# UNITED STATES PATENT AND TRADEMARK OFFICE

APPLICATION NO.	FILING DATE	FIRST NAMED INVENTOR	ATTORNEY DOCKET NO.	CONFIRMATION NO.
09/590,586	06/08/2000	William W. Holmes IV	U6220/53569/NWJ-gasket	1012

# Office Action Summary

## **DETAILED ACTION**

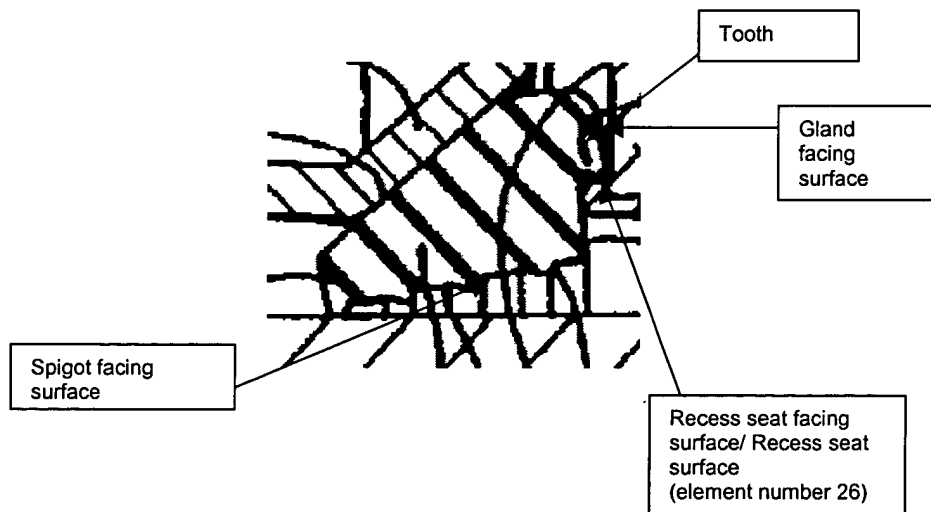
Re: claims 2, 3, 4, 5, 11, and 16. Harper shows in figure 1 a pipe joint comprising a male first pipe portion 4, a female second pipe portion 2, a compression gland 6 having a lip 8 located at an inner diameter of the gland disposed at least

partially within (the extrapolated boundaries of) the second pipe portion to the same extent as Applicant's, and a restraining gasket shown in the area of element number 10 within the second pipe portion and between the first pipe portion and the second pipe portion, the gasket further comprising: a compressible body having a spigot-facing surface, a recess seat-facing surface and a gland-facing surface, but does not include the limitation of a locking member.

Miller teaches in figure 16 the use of a locking member 72 (being of the form illustrated in figure 1 as disclosed in the left column of pg, 4 lines 22-23), the locking member 72 having a tooth 72b and a back portion or upper surface at least partially embedded within a compressible body 61 wherein at least a portion of the tooth is positioned to engage a first pipe portion 10 wherein the locking member is adapted to pivot (as a result of the conical end portions 60 of element 13c in which the front portions of the locking member are wedged and as a result of the rear portions 73 being supported) in response to a force tending to separate the first pipe portion from the second pipe portion, and wherein the locking member is adapted to resist movement between the first pipe portion and the compression gland in the event of such force.

It would have been obvious to one of ordinary skill in the art at the time the invention was made to have modified the gasket of Harper to have included a locking member, as taught by Miller, in order to provide a means of more securely connecting the first and second pipe portions.
